# 6511340

Direct Replacement for gpd #6511339

gpd # 6511340

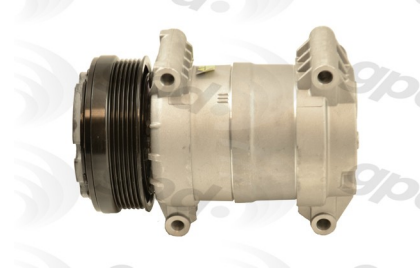
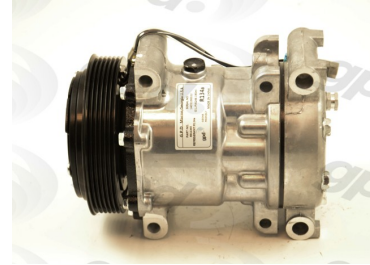
gpd compressor 6511340 is a Sanden style replacement for the OEM H6 style compressor. Just like its OEM counterpart, this is a very efficient compressor for GM light duty trucks from 1996 through 2002. This compressor is made using the dependable Sanden style body.

The look of the compressor does vary from the OEM compressor but mounts and functions the exact same.

Like all aftermarket units for these applications, it does not include the high pressure compressor switch mounted in the rear head. The original switch, which was held in place by a snap ring, can easily be removed from the OEM unit and then installed into the replacement unit.

After the snap ring is removed, use gpd #5811490 switch puller to remove the original switch, to ensure no damage occurs to the switch.

If the original switch is damaged, replace it with gpd #1711334, high pressure compressor switch.
